CAUTION NOTICE

DVX001-CAU-2013

Oral Nasal Caution Notice

Products Affected

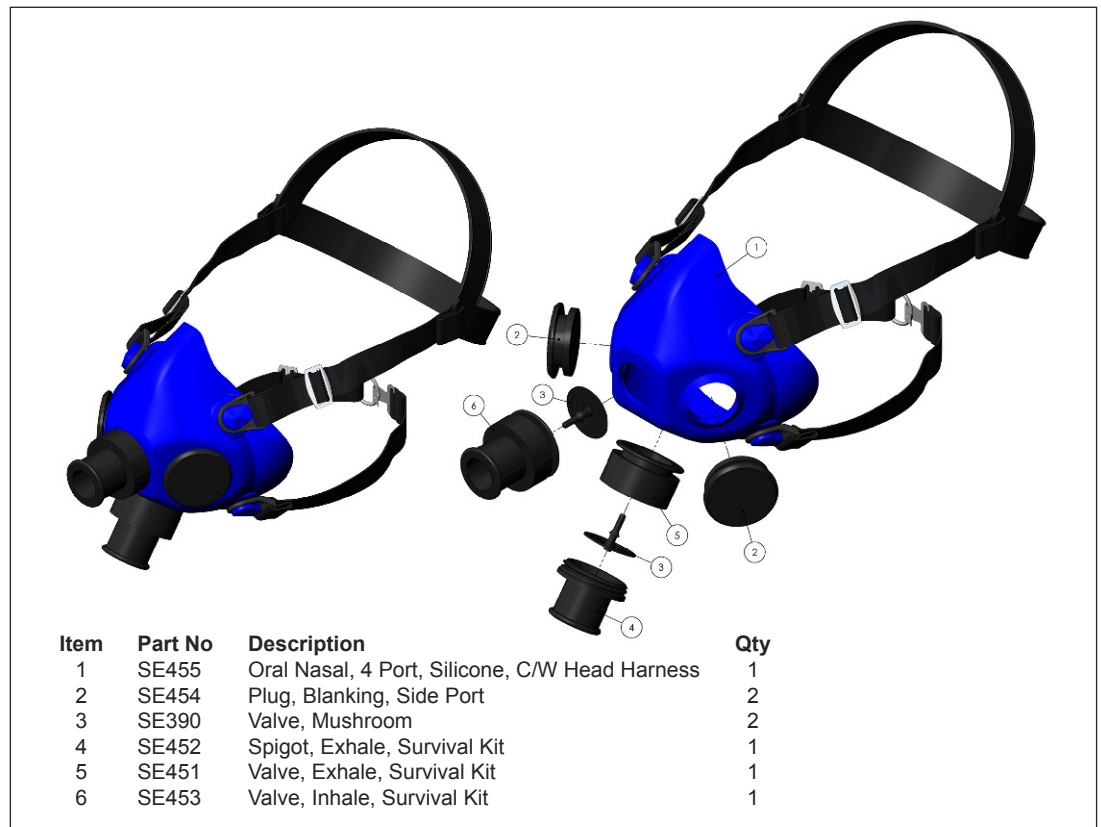
Following feedback from clients in the field we wish to make customers aware of changes to part numbers and components used within our range of Bell Survival Kit Lung Powered Scrubber Assemblies.

When conducting planned maintenance of these kits it may be necessary to replace the Oral Nasal Mask (SE455). If this is the case then please ensure that the corresponding Inlet & Exhaust Valves, spigots and blanking plugs are also replaced with the new versions.

THE VALVES, SPIGOTS AND PLUGS FROM THE PREVIOUS SURVIVAL KIT ARE NOT SIZED TO FIT THE NEW ORAL NASAL HENCE THE REQUIRED SEAL IS NOT ACHIEVED.
